SUBJECT: JOSEPH M. FARLEY NUCLEAR PLANT, UNITS 1 AND 2 – ISSUANCE OF
AMENDMENTS RELATED TO TECHNICAL SPECIFICATION 3.3.5
(CAC NOS. MF7106 AND MF7107)

SAFETY EVALUATION BY THE OFFICE OF NUCLEAR REACTOR REGULATION

AMENDMENT NO. 206 TO RENEWED FACILITY OPERATING LICENSE NO. NPF-2

AMENDMENT NO. 202 TO RENEWED FACILITY OPERATING LICENSE NO. NPF-8

Table 1: Margin Between the TLU and the Associated Analytical Safety Limit Calculation

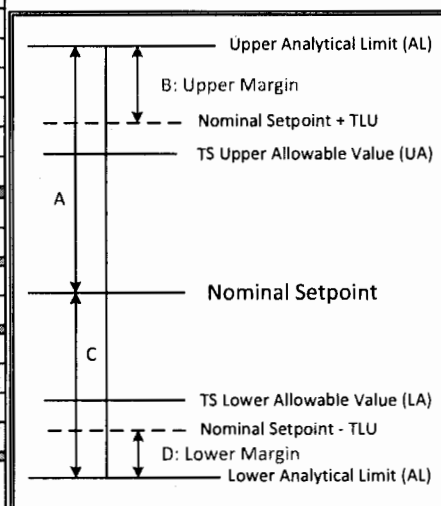
The NRC staff calculated the margin between the TLU and associated analytical limit using the margin equation above, and the calculation results are reflected in Table 1 below, rows 12 and 15.

TLU: The loop uncertainties VAC (voltage AC) at secondary side (at relay) are reflected in Table 1a of Calculation SJ-SNC529029-001, Sheet 1. For the primary 4.16 kV AC side of the potential transformer, the NRC staff calculated the CSA (equivalent to TLU) per CSA equation (3) above.

The NRC staff reviewed the proposed FNP LAR against the criteria of RG 1.105 to ensure that setpoints for safety-related instrumentation are initially within and will remain within the technical specification limits. The NRC staff determined that sufficient margin exists between the NTSP and the AL such that the undervoltage relay safety function meets the performance criteria of RG 1.105. The methods described in RG 1.105 provide an acceptable way to satisfy criterion 13, "Instrumentation and Control," and criterion 20, "Protection System Functions," of Appendix A to 10 CFR Part 50. This method combines the various uncertainty types associated with the instruments and applies them to the TLU calculation. It also compares the uncertainties in determining a trip setpoint against the available margin between the analytical limits and the TS nominal setting. That is, there is 95 percent confidence level of achieving the required safety function at a 95 percent performance level.
